MODEL
2017MY Sportage
(QL)

NUMBER
035

TECHNICAL SERVICE BULLETIN

SUBJECT: A/C EVAPORATOR CORE REPLACEMENT

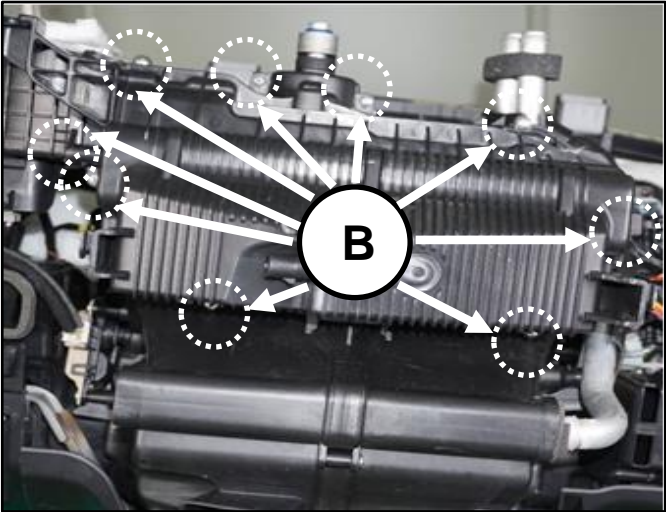
1. Recover the refrigerant by referring to "Heating, Ventilation, Air Conditioning (Air Conditioner) → Air Conditioning System → Repair procedures" chapter in the applicable Workshop Manual found on KGIS.
2. Remove the evaporator core assembly by referring to "Heating, Ventilation and Air Conditioning → Air Conditioning System → Evaporator Core → Repair procedures" chapter in the applicable Workshop Manual found on KGIS.
3. Disconnect connector (A).
Remove the evaporator temperature sensor.

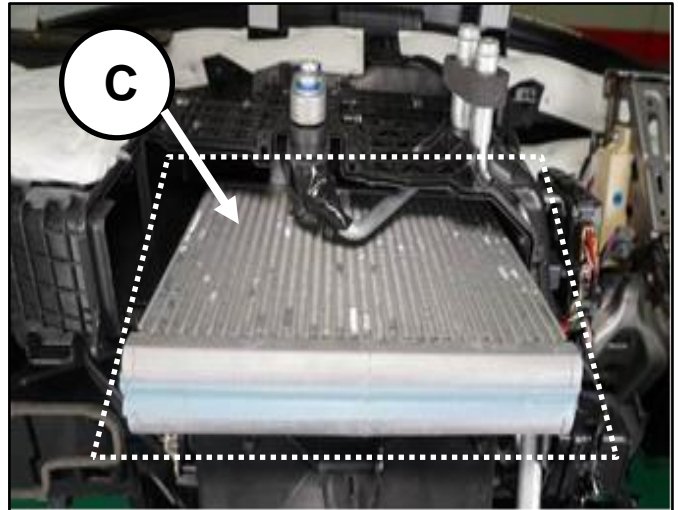
4. Loosen the nine (9) heater-cover fixing screws (B) and remove the lower cover.

5. Remove the evaporator core (C) from the heater unit.

6. Replace the evaporator core with a new one.
